REVISED PER ENGINEERING CHANGE: CD500368

DUKE POWER COMPANY
CATAWBA NUCLEAR STATION UNITS 1 & 2
NUCLEAR SERVICE WATER & STANDBY NUCLEAR SERVICE WATER INTAKE AND DISCHARGE PIPE LAYOUT, DETAILS, & SECTIONS

Scale: Noted | DWG. NO. CN-1345-2 | REV 22A

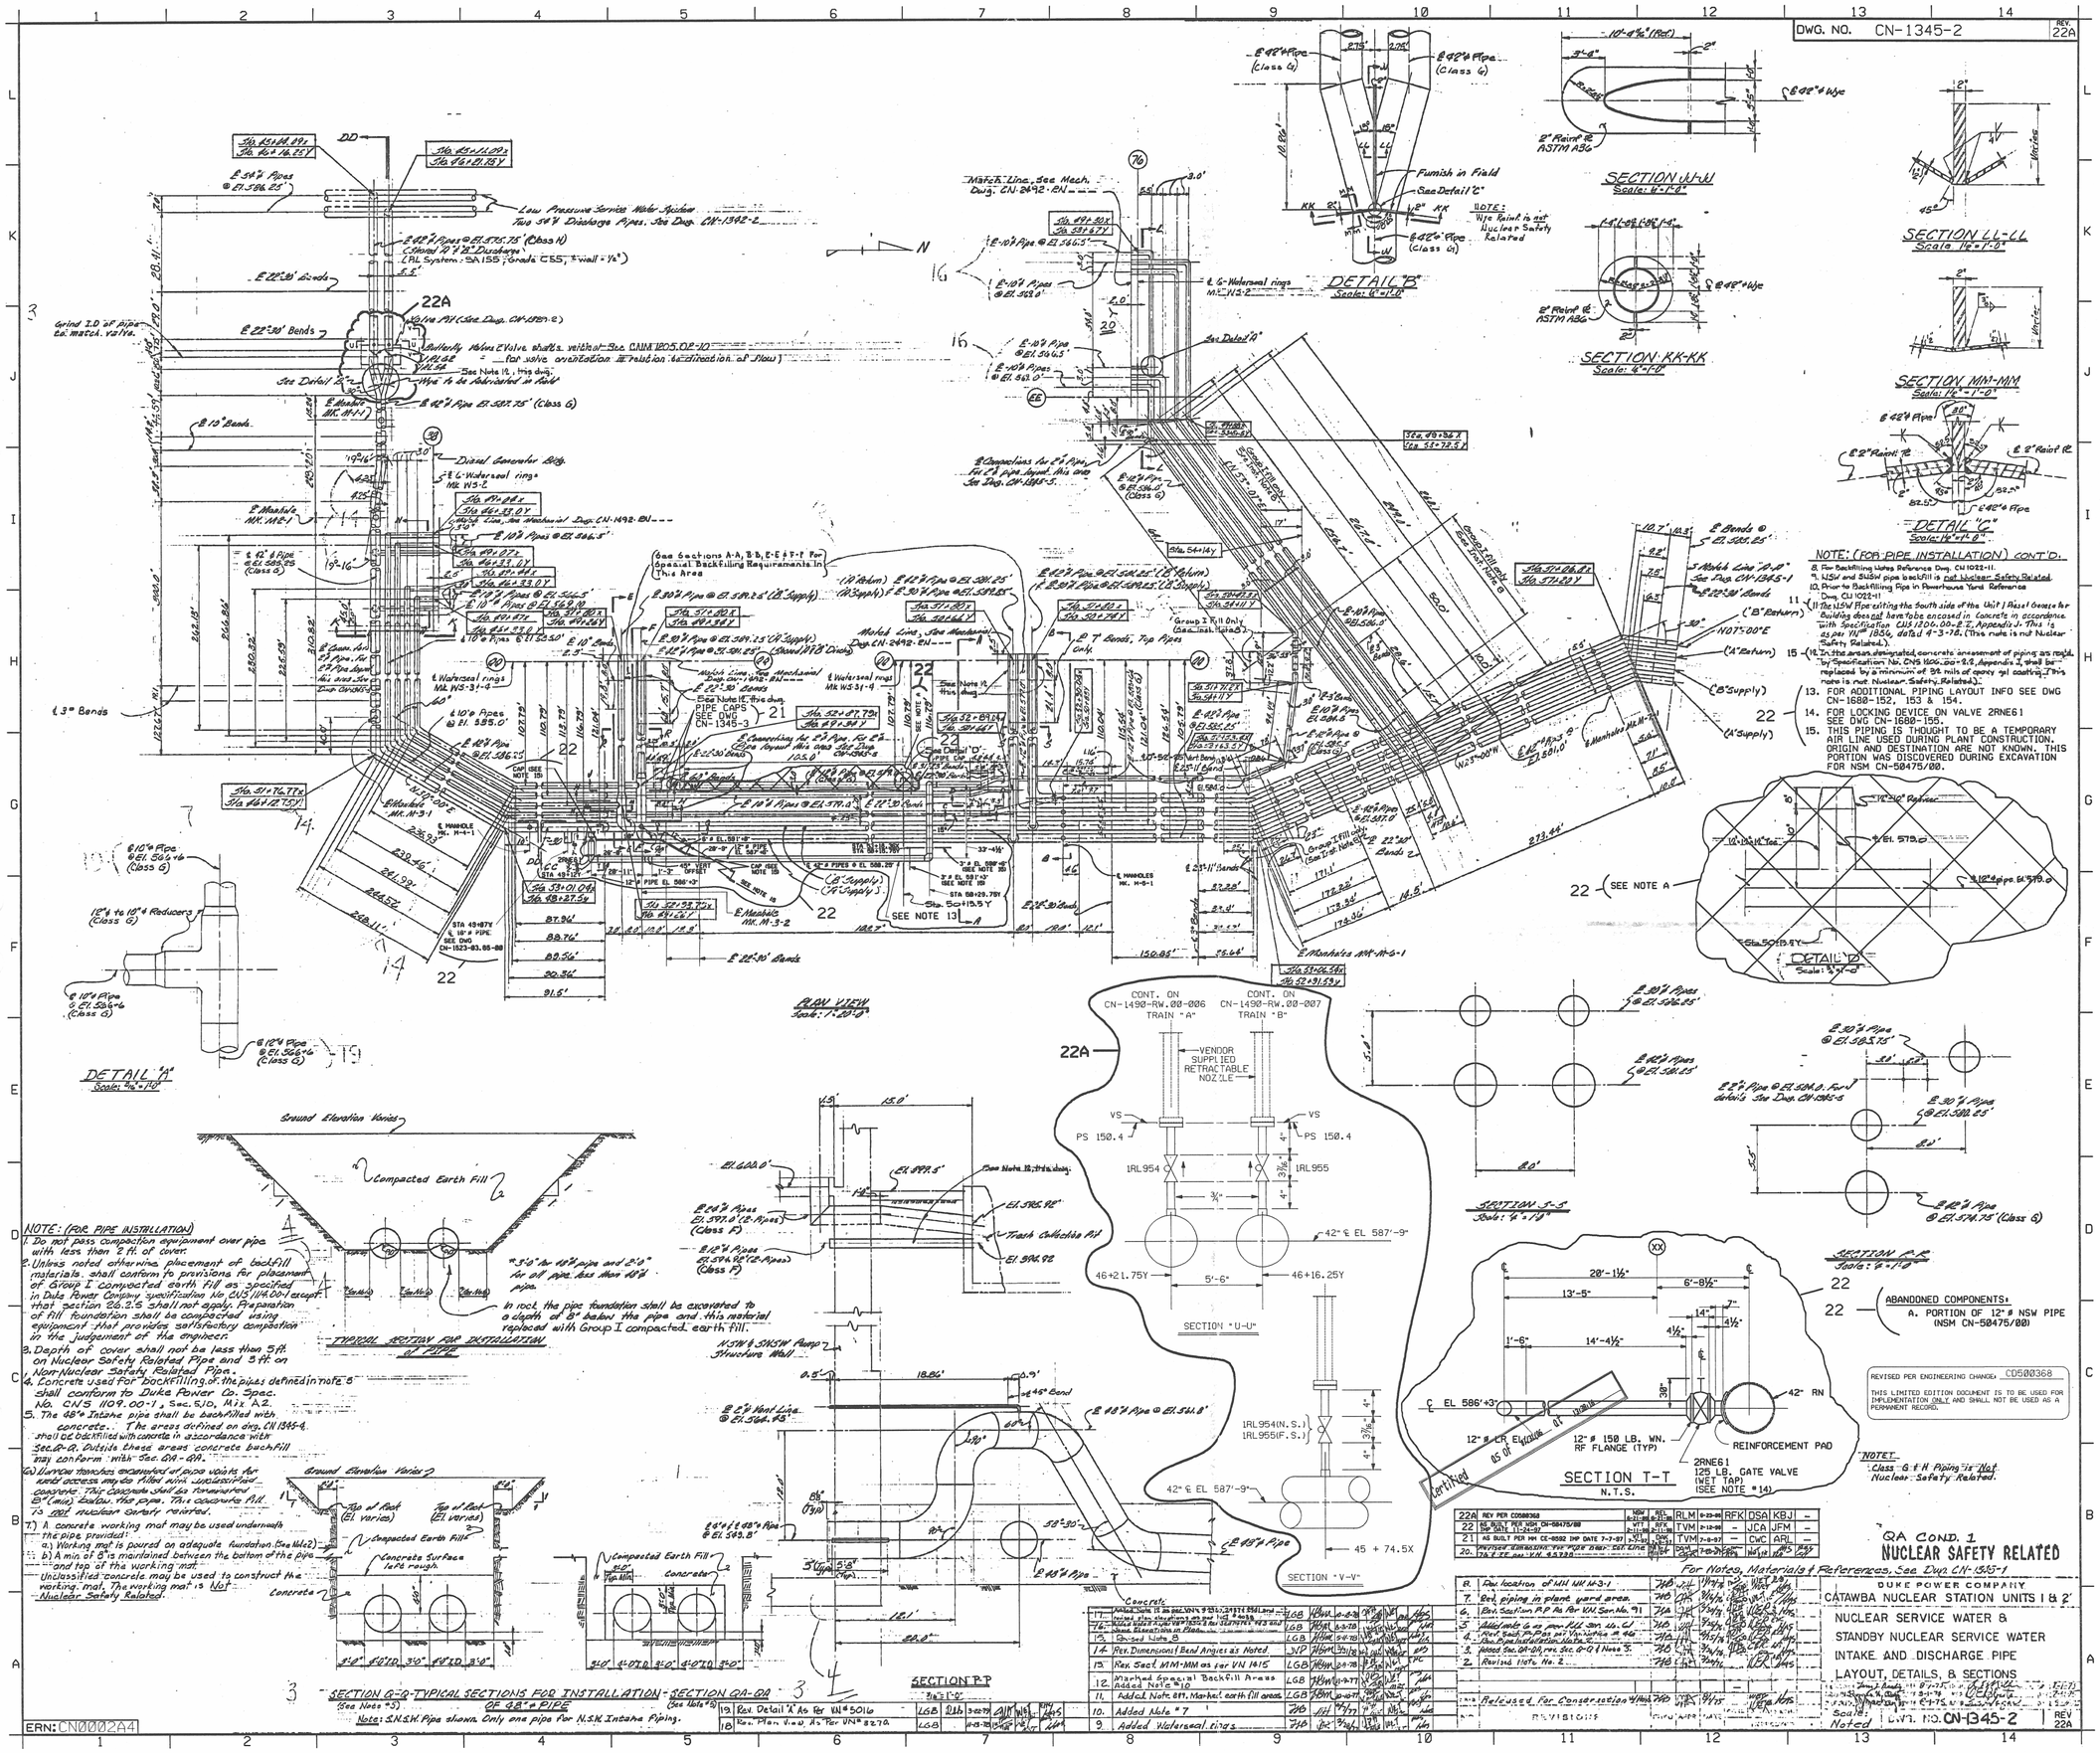
REV	DESCRIPTION	DES	DRN	CHK	APP
22A	REV PER CO500368	NSW 6-21-88	RFL 6-23-88	RLM	6-23-88	RFK	DSA	KBJ	–
22	AS BUILT PER NSM CN-50475/00	WTJ 11-1-96	RFL 11-1-96	TVM	7-13-96	–	JCA	JFM	–
21	AS BUILT PER MM CE-0552 IMP DATE 7-7-97	CWC 7-8-97	CWC 7-8-97	TVM	7-8-97	–	CWC	ARL	–
